BIDDING ADDENDUM

ADDENDUM#: 01
Date: 8.27.26
Project: Bank of Utah Spanish Fork
Project #: 26002

Clarifications and bidder question responses.

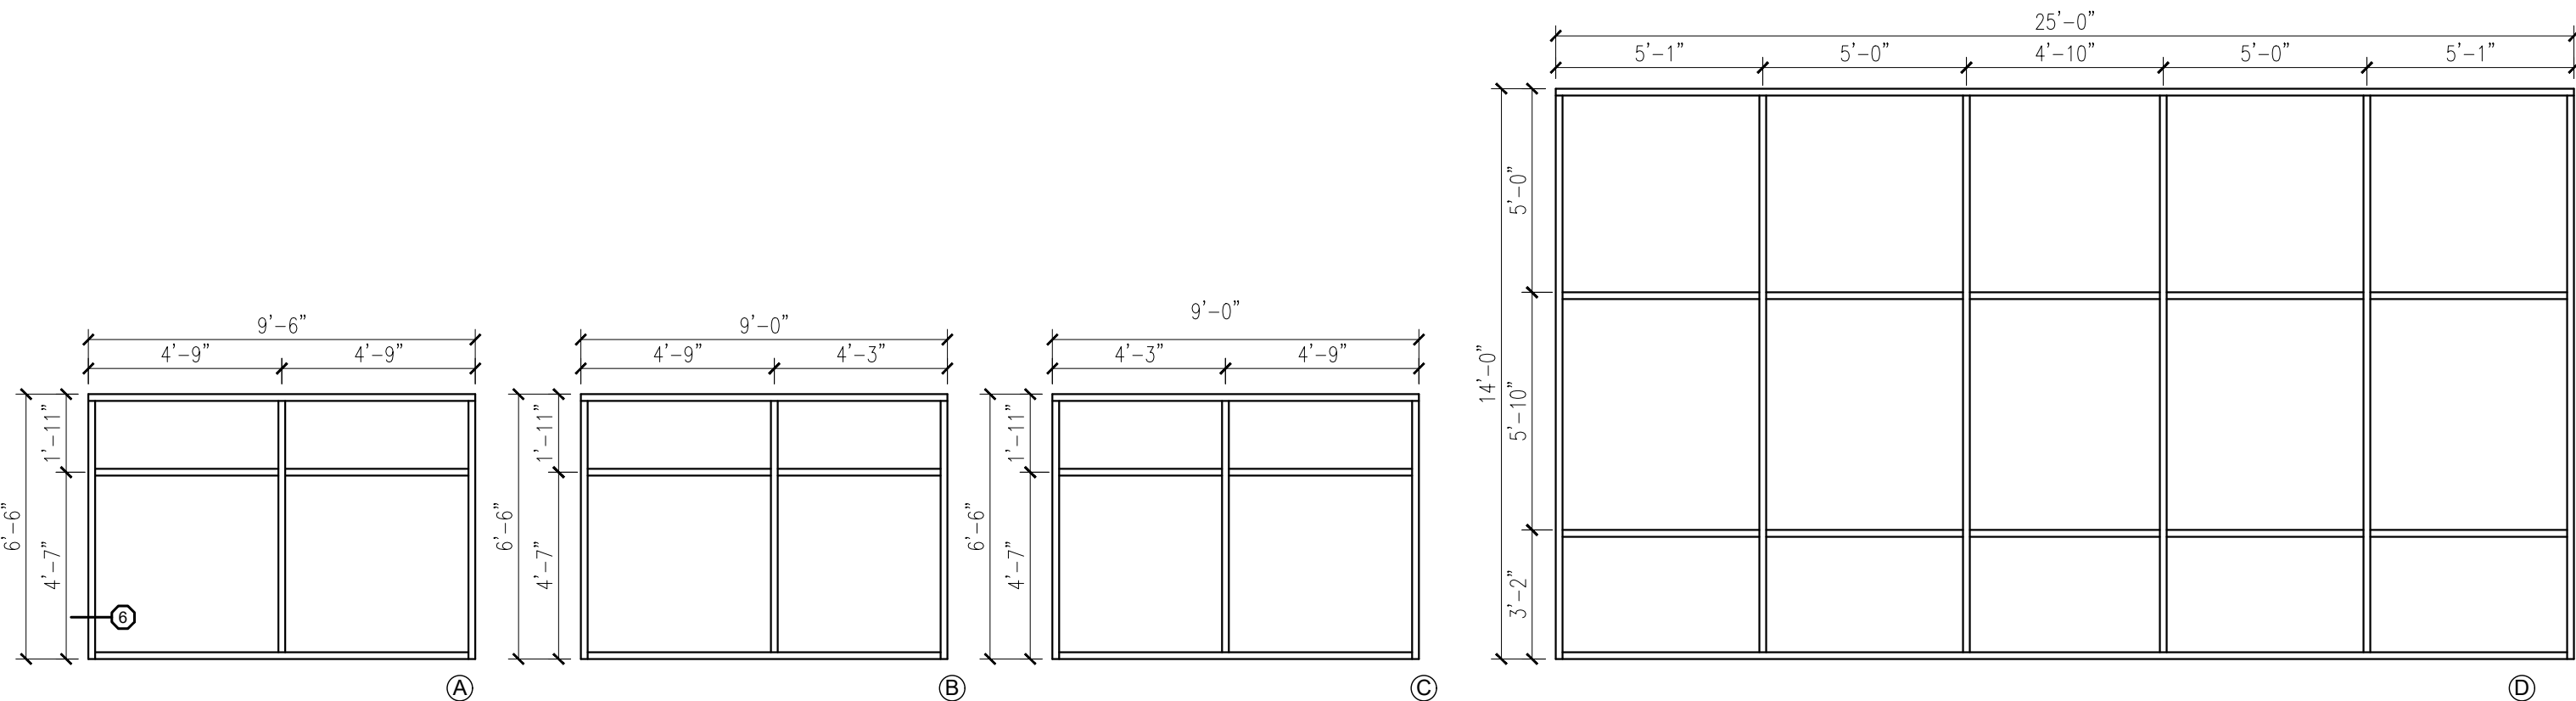
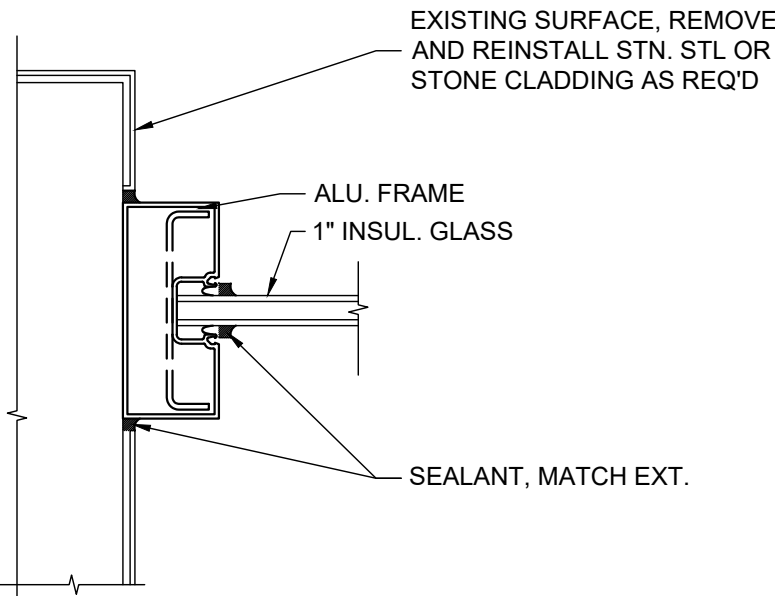
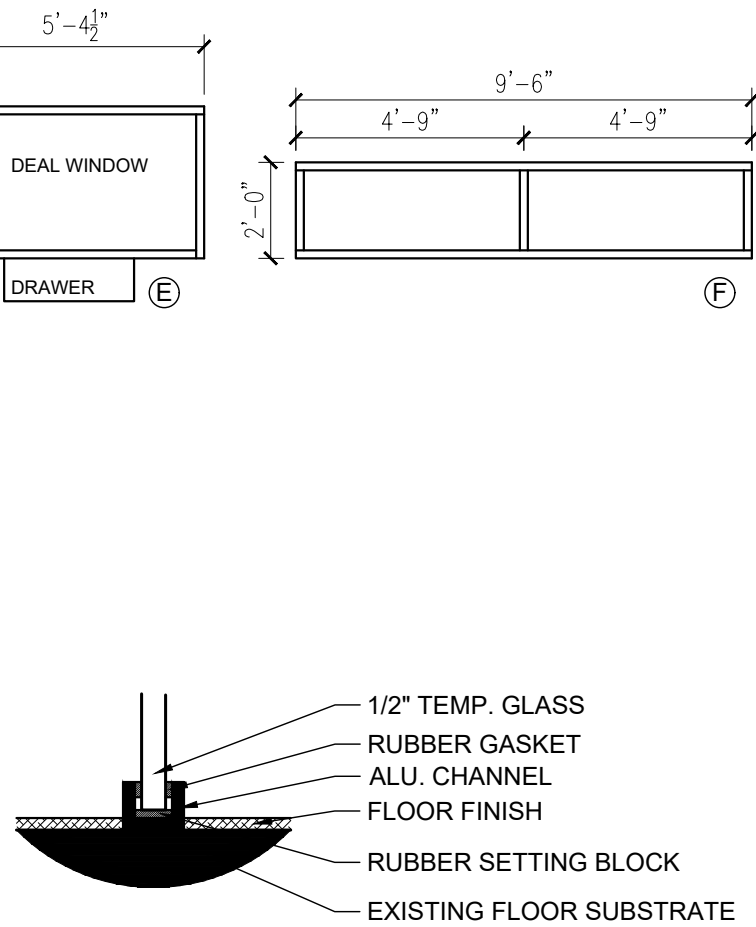
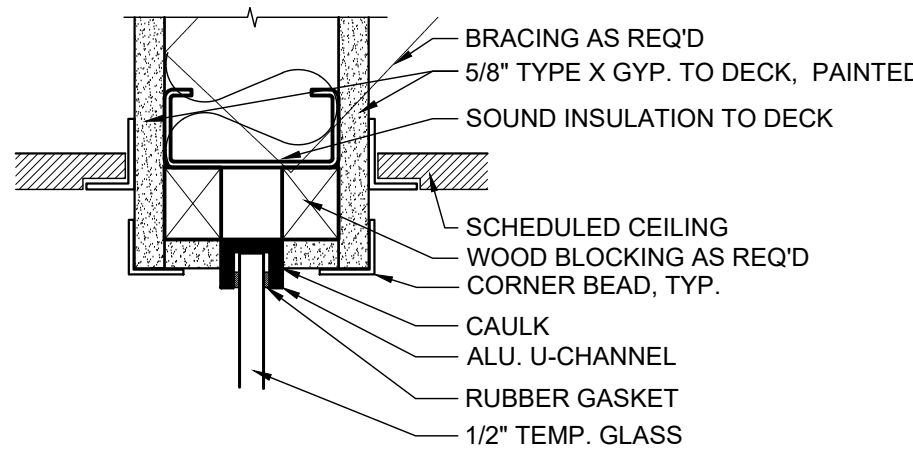
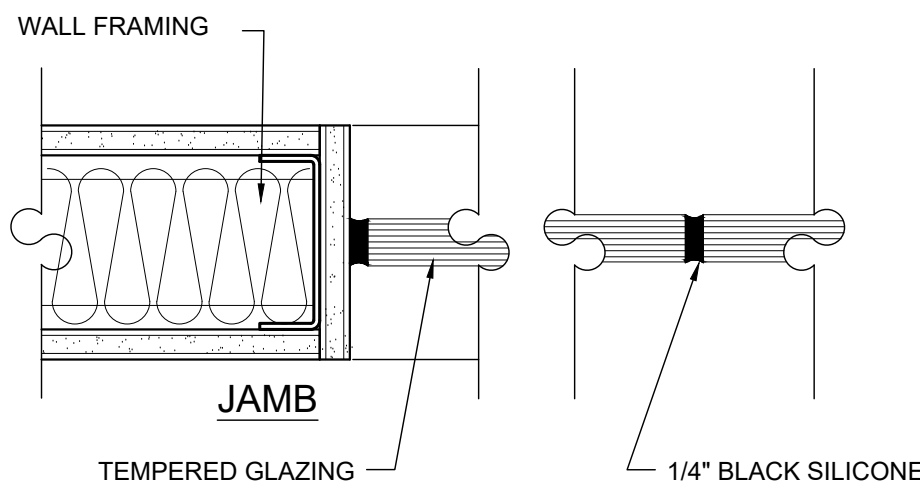
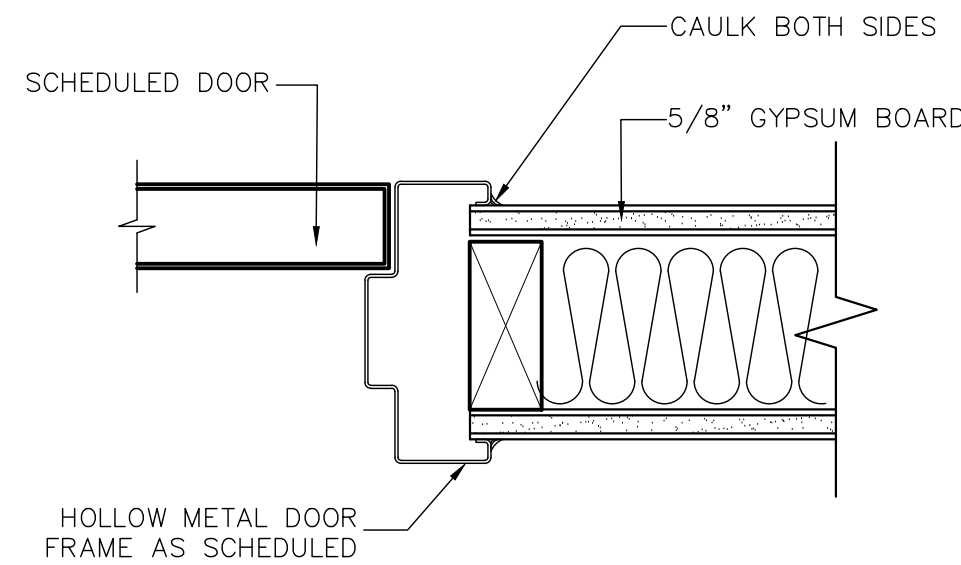
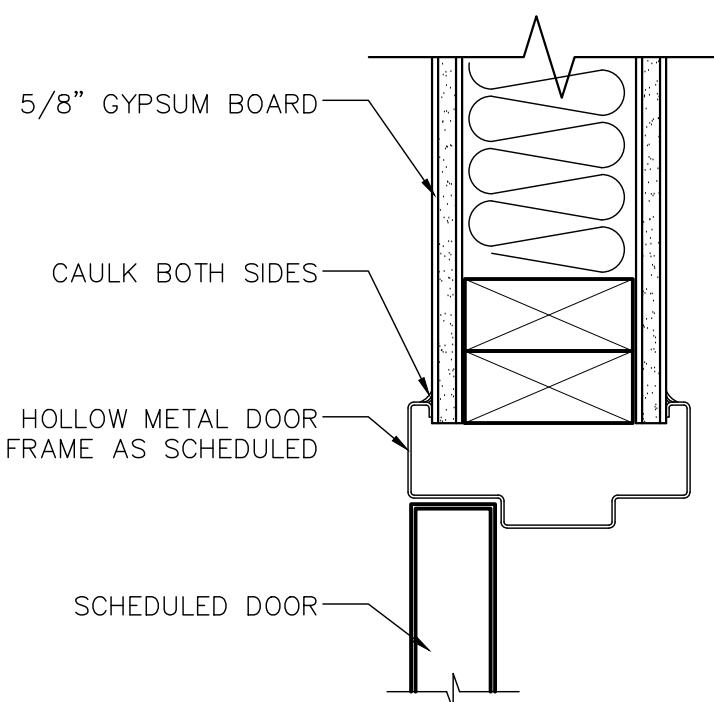
A601

- Clarification to aluminum frame
